WEINAM CREEK PRIORITY DEVELOPMENT

AREA - STAGE 3A

WEINAM CREEK, REDLAND BAY. FOR REDLAND INVESTMENT CORPORATION.

PLANS AND DOCUMENTS
referred to in the PDA
DEVELOPMENT APPROVAL

PIT DETAIL 2/2
SCALE: 1:50

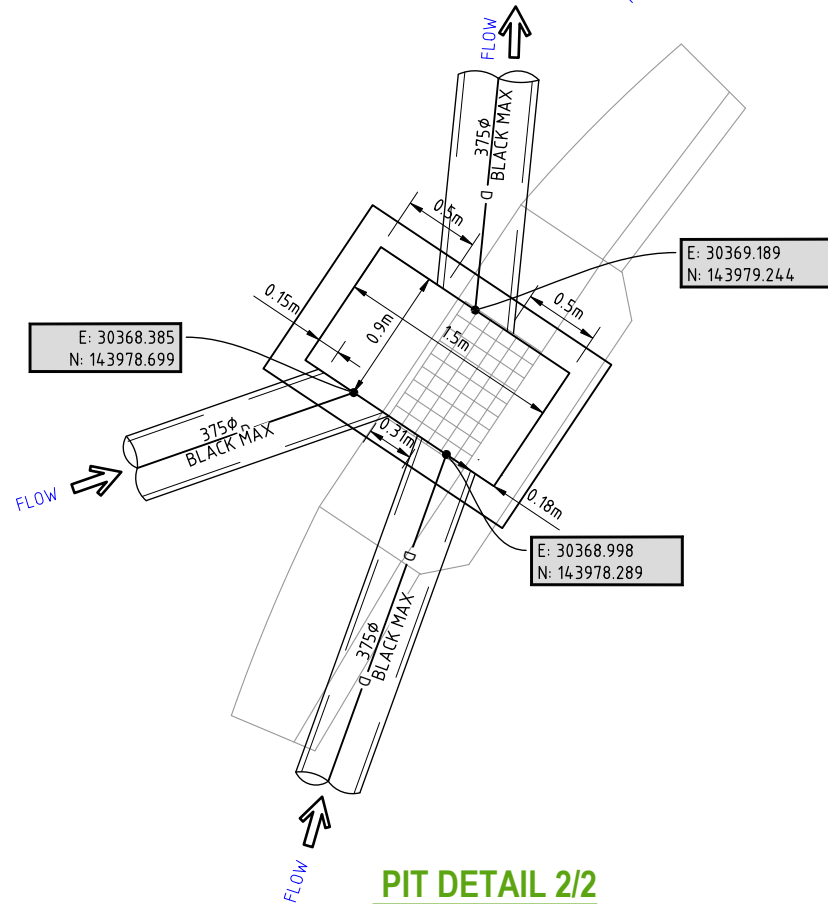
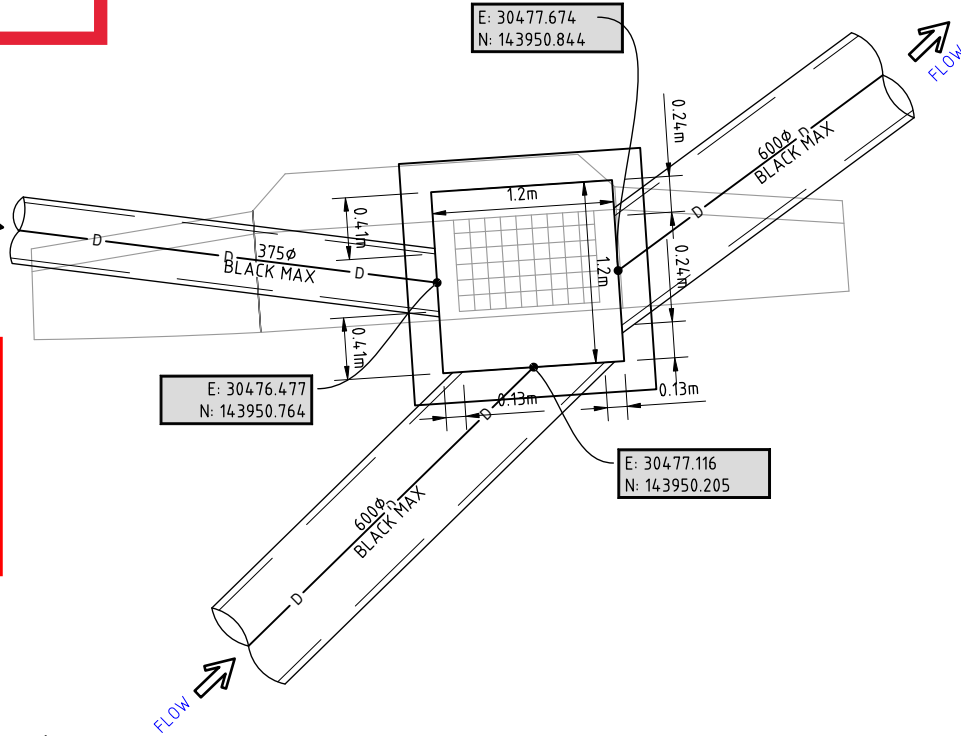
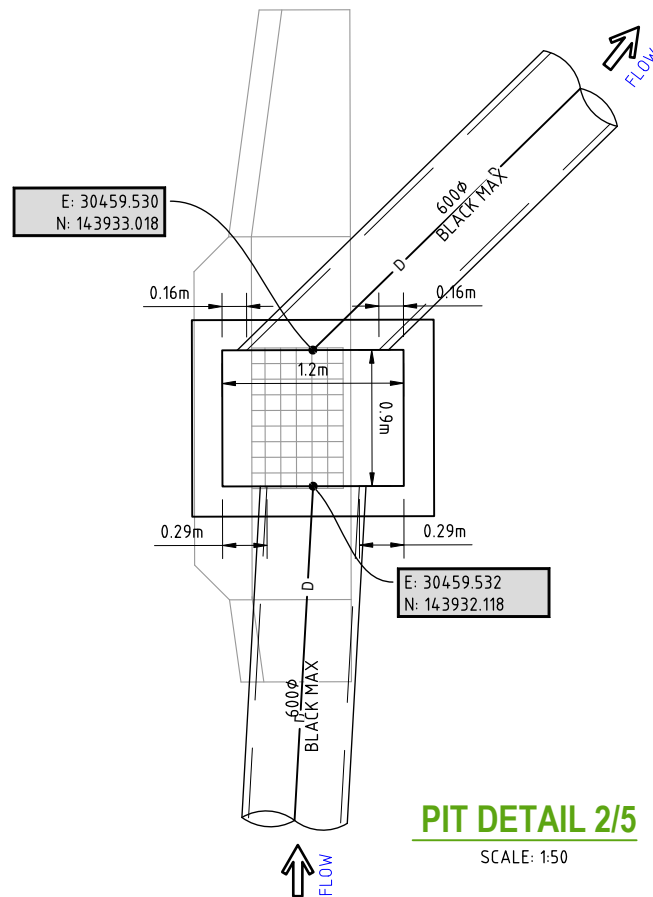
AMENDED IN RED: All Stormwater Structures to have saltwater cover.

AMENDED IN RED

CHAINAGE 53.012													
DESIGN HEIGHT	6.471		5.477	5.327	5.367	5.457		5.370	5.330	5.480	5.520	5.550		4.712
EXISTING SURFACE	6.471		5.450	5.424	5.353	5.457		5.369	5.433	5.474	5.515	5.507		4.712
DESIGN OFFSET	-10.566		-4.208	-4.058	-3.608	0.000		3.491	3.941	4.091	5.416	6.633		9.948

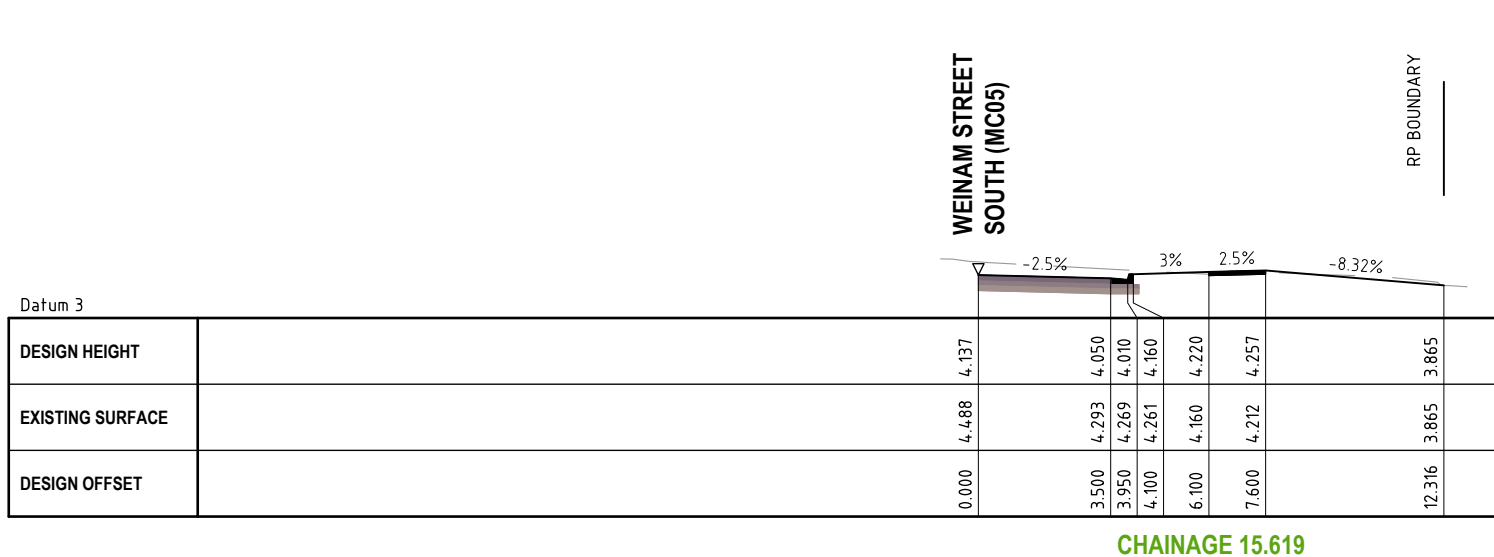
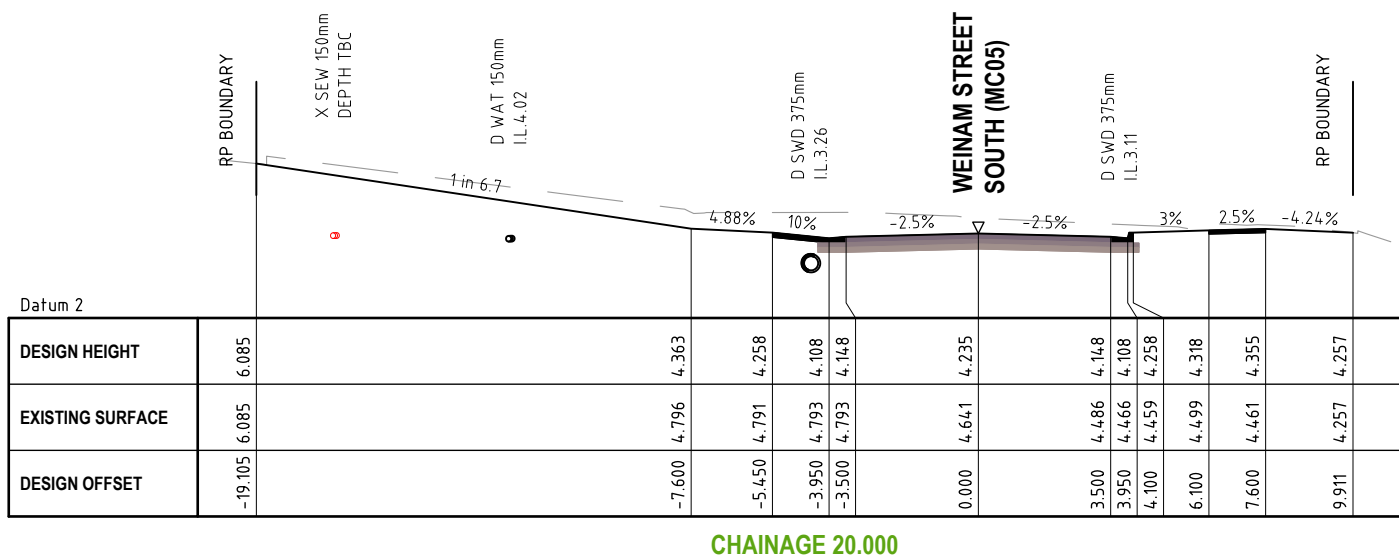
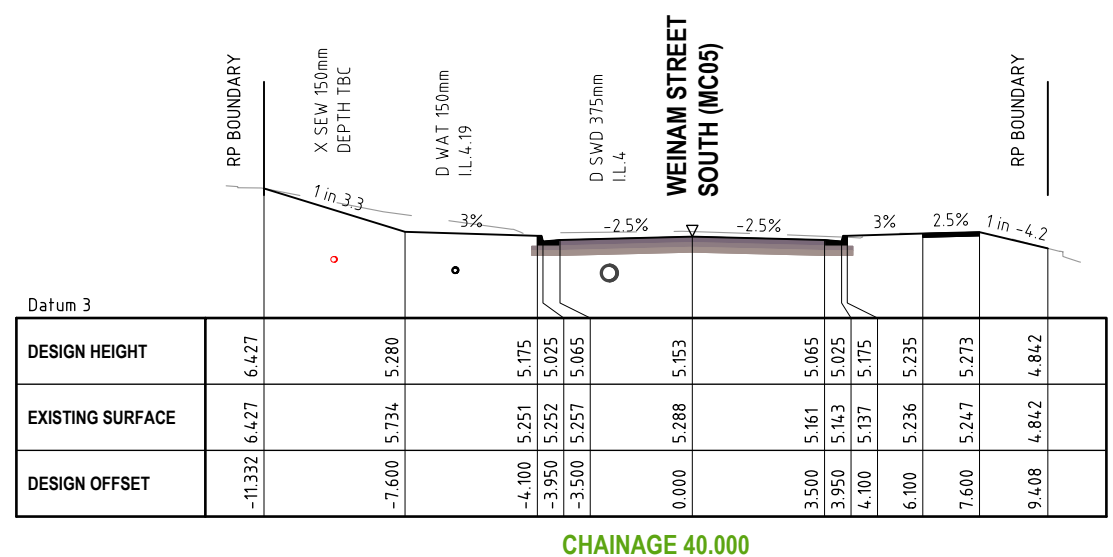
AMENDED IN RED: The design surface of cross sections must interface with the existing surface.
